Raspberry Pi 4 Model B

PCN 30 – Alternative sources of RAM

Notification of alternative sources of RAM devices for Raspberry Pi 4 Model B.

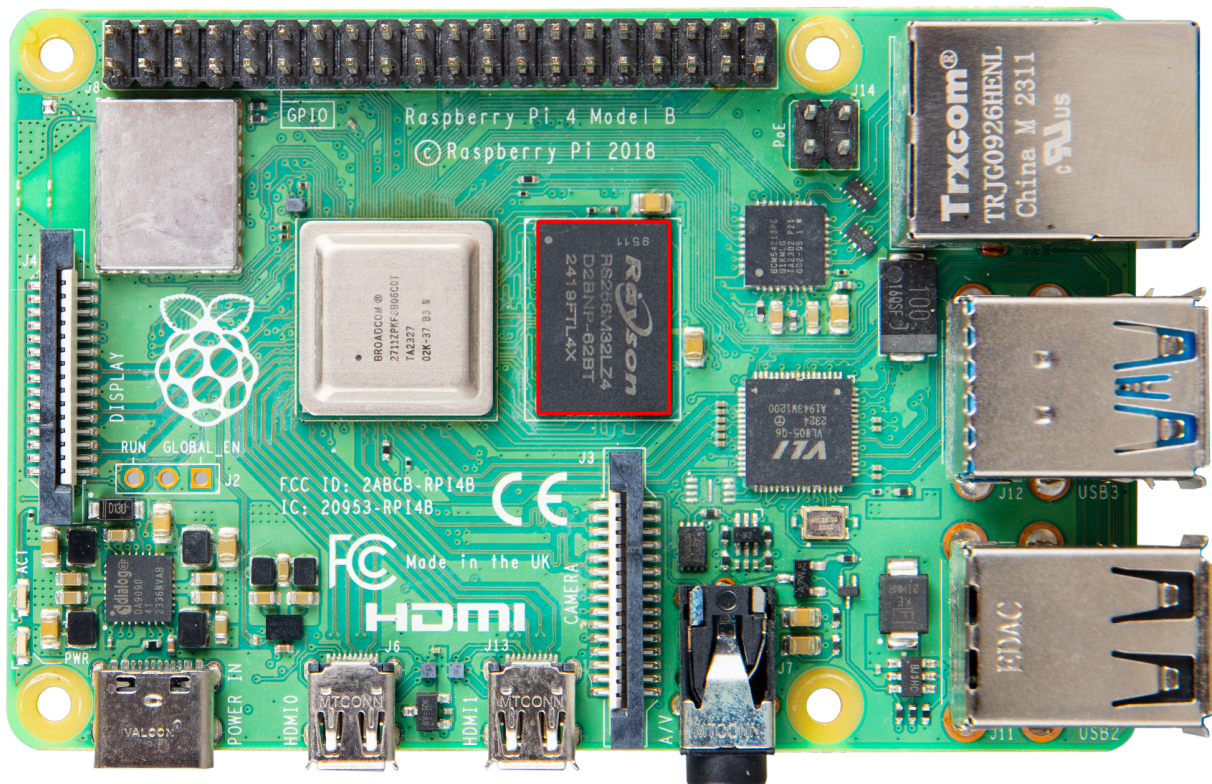
The changed product can be distinguished by examination of the RAM chip device as shown by the highlighted Rayson part in the diagram below.
